Thorndon connections cycleway audit - safety and accessibility

90% design audit

Paneke Pōneke
Bike network plan

Absolutely Positively
Wellington City Council
Me Heke Ki Pōneke

Figure 4-2: cycleway transition in vicinity of bus stop and pedestrian crossing

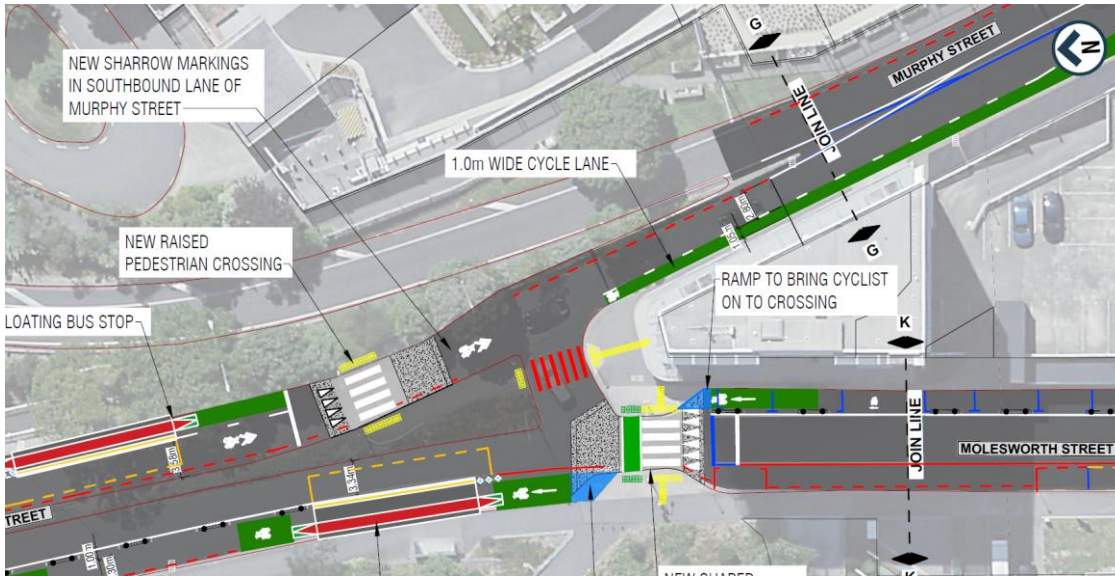
The safety issue is that the merge point for cyclists and motorists appears to be on the pedestrian crossing platform; this could cause confusion for cyclists or motorists and could ultimately result in motorists failing to merge correctly with cyclists or give way to pedestrians on the crossing.

Firstly, shifting the bus stop back has improved the distance available for cyclists and motorists to merge.

Disc
onti
nue
the
cycl
e

lane prior to the pedestrian crossing, to avoid having the merge beginning on the crossing itself.

| Designer | Agree with the CAT, to amend design of merge |
| Proposed action | Update plans |

Figure 4-3: narrow cycle lane on Murphy Street

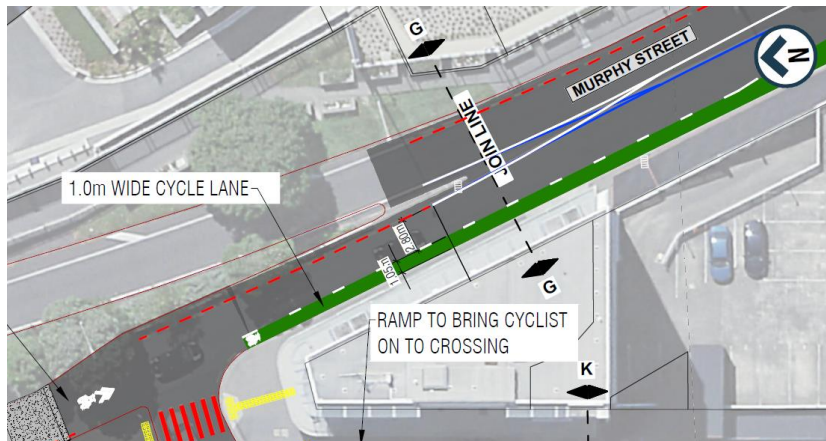
The safety issue is the cycle lane on Murphy Street after the pedestrian crossing (see Figure 4-3) is too narrow.

The risk factors include cyclists and motorists having a false sense of security thinking they each have their own spaces when there is not enough width for this form of provision and the carriageway constraints between the solid median island and the footpath kerb.

The relevant standards are outlined in the CNG section on [cycle lanes](#), which specifies an absolute minimum cycle lane width of 1.4 m (adjacent to a kerb, in low speed environments, for short sections).

4.3.1 Continue the mixed traffic section with sharrowes at least up to the end of the solid median island and begin the cycle lane after that.

| Designer | Agree with CAT, to shift start of cycleway further down Murphy St at which point a full width traffic lane and cycleway can be provided |

Figure 4-4: Mixing lane with defined merging length

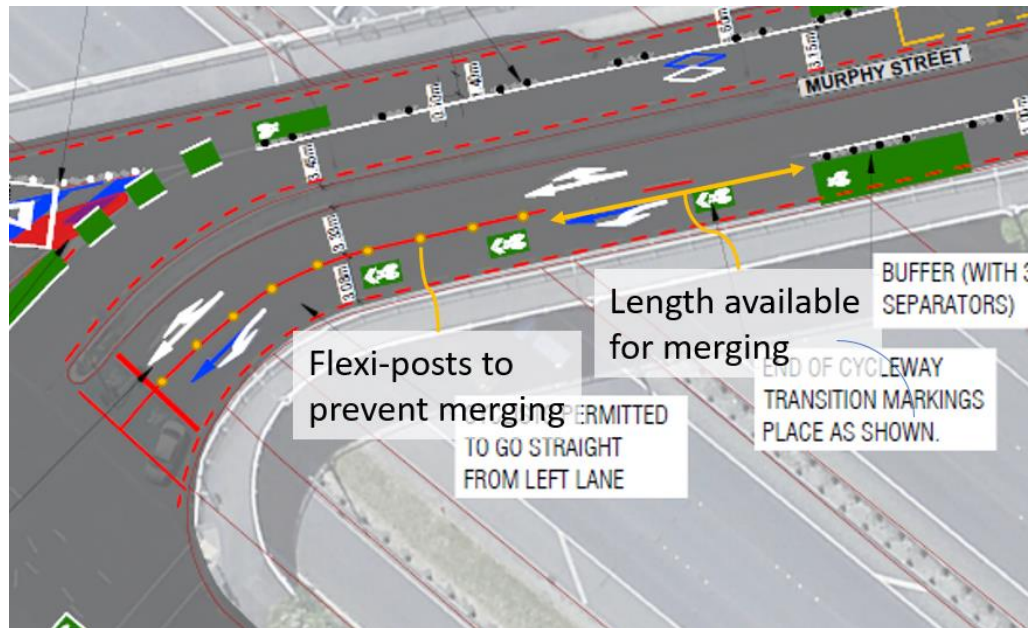
The safety issue is the long section available for merging in the mixing lane on Murphy St approaching Tinakori / Park. This length means drivers can enter the mixing lane at greater speeds, and cyclists are exposed to conflict over a greater distance.

The length of the lane itself is determined by queue length requirements, but it is not necessary that the entire length is accessible to merging vehicles. It would be preferable to reduce the length available for merging to reduce speeds of vehicles entering the mixing lane,

| 4.4.1 | Restrict the merge area of the mixing lanes e.g. by adding flexi-posts along (at least some of) the lane line from the limit line. The extent should be based on vehicle tracking to enter the mixing lane, and vehicle tracking within the lane should also be considered. Figure 4-4 illustrates the concept. |

reduce the size of the zone of potential conflict and increase predictability.

| Designer | Agree with CAT, to restrict length available for merging |

Figure 4-5: Likely cyclist non-compliant manoeuvres and resulting conflicts

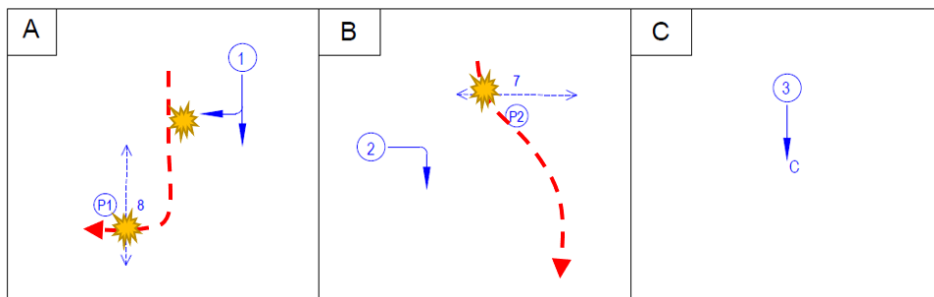
The safety issue is the fully protected cycle movement at this intersection will increase cyclist waiting time, reduce cyclist LOS, and lead to some cyclists undertaking unsafe manoeuvres.

The problem is that, in either the A or B phase, there will be cyclists waiting at the limit line believing that they could progress safely, and some cyclists will choose to run a red light to improve their efficiency – these are illustrated in Figure 4-5. In the B phase, cyclists travelling along Mulgrave Street would be safe to cross on a sharp diagonal, provided they do not conflict with any pedestrians crossing Mulgrave Street. In the A phase, cyclists turning right might do so, but they would risk conflict with any pedestrians crossing Aitken Street and, of greater concern, they would be at risk of being hit by vehicles turning right into Aitken Street.

Furthermore, whilst one cyclist may be able to judge a safe manoeuvre, subsequent cyclists may follow along without adequately judging the situation. For example, a confident right turning cyclist may move in the B phase, knowing they can make it before an approaching right turning vehicle, but the cyclist behind them may not notice the vehicle or judge the

| 4.5.2 | Double-cycle the C phase to increase cyclist level of service and decrease the chance of a cyclist waiting at the limit line when there is no conflicting traffic. |

| Responses: | |
|------------------------|--|
| Designer | Agree with CAT, proposed operation of the intersection was to have a short cycle time to reduce wait for cyclists. To consider double running phase C as a way to achieve a similar outcome. |

Figure 4-6: Existing illegal manoeuvre from Kate Sheppard Place eastern end

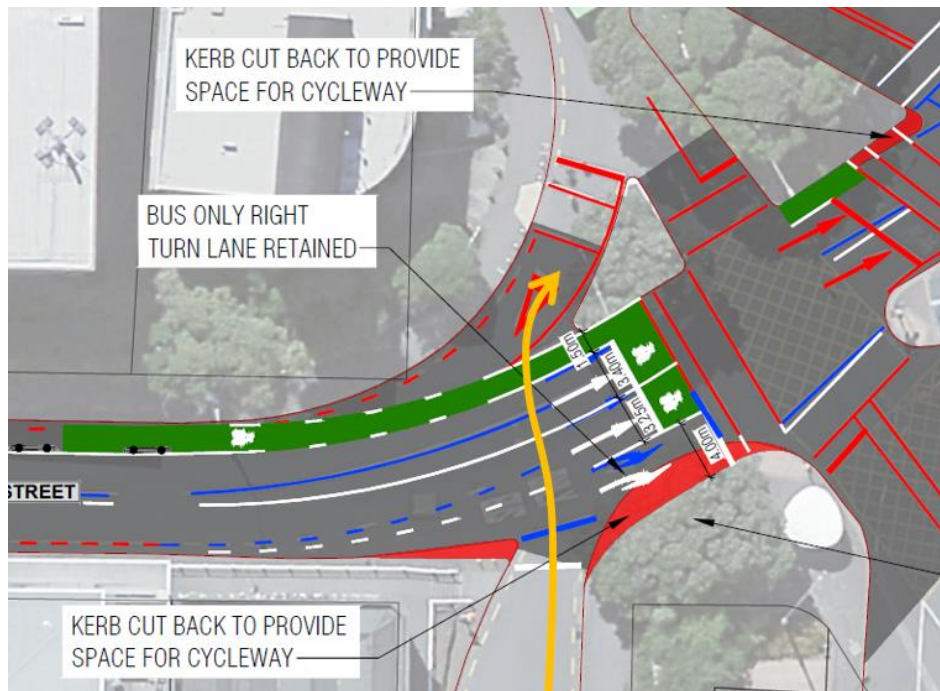
| 4.7.1 | Make the western end of Kate Sheppard Place entry-only from Molesworth Street. |
| 4.7.2 | Monitor the eastern end of Kate Sheppard Place; if breaches of the right-turn only restriction increase, request additional police enforcement. |
| 4.7.3 | Consider physical devices that make the illegal movement more difficult, e.g. flexiposts on the edge of the cycle lane. |

The CAT acknowledges that adding the cycle lane would worsen the consequences of this existing illegal manoeuvre, as drivers then have an additional lane to cross and cyclists are more vulnerable than motorists. However, we suggest that the risk to the cyclists on Murphy Street would not be as great as the risk to the contraflow cyclists on Molesworth Street, as the Murphy Street cyclists are travelling in the same direction as the general traffic and therefore more likely to be seen the drivers exiting Kate Sheppard Place. Furthermore, it

would be easier to enforce the right-turn only out of the eastern end of Kate Sheppard Place than to ensure drivers turning right out of the western end look for contra-flow cyclists.

| Proposed action | Update plans and monitor |

Figure 5-1: Different chicane designs on Hill Street

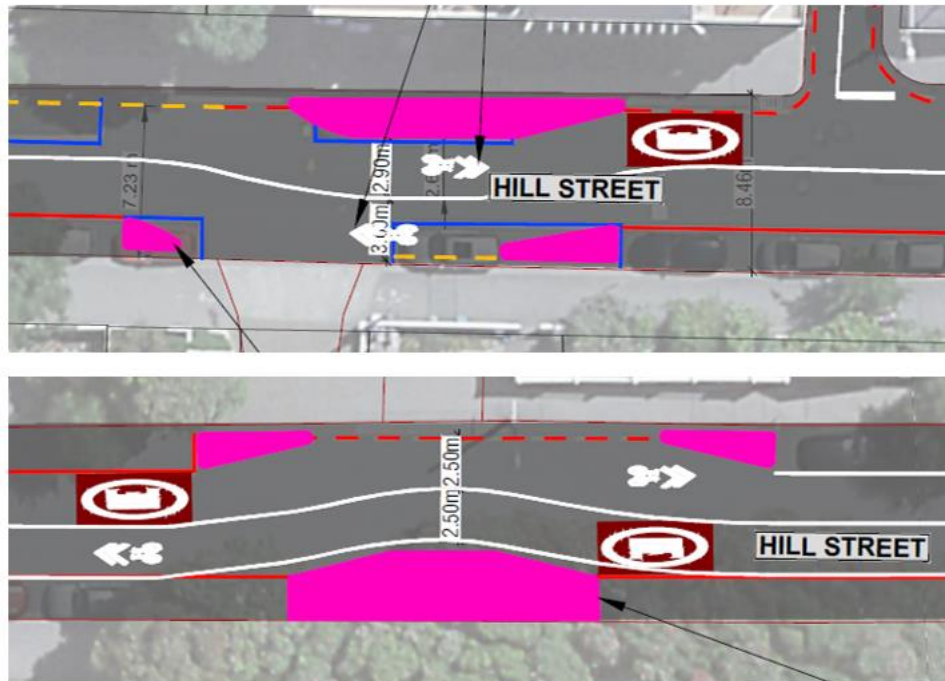
The two chicanes on Hill Street employ different marking layouts regarding the use of the 30 and sharrows markings (Figure 5-1). It would be preferable to have a consistent design.

| Action taken | Plans updated |

Figure 5-2: Gap between limit line and pedestrian crosswalk

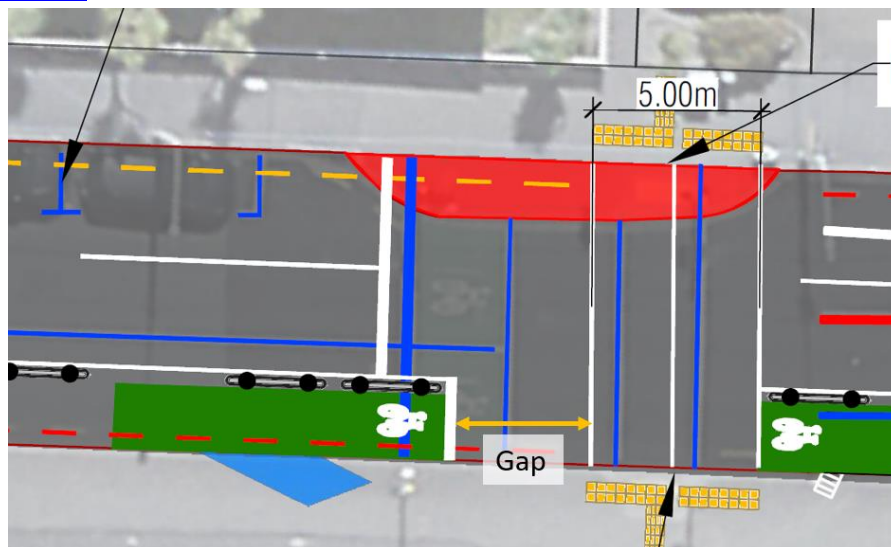
There is a large gap between the advanced stop line and the pedestrian / cycle midblock crossing line; this is only required to be 200mm – see CNG section on [cyclist waiting facilities at intersections](#).

| Proposed action | Update plans |
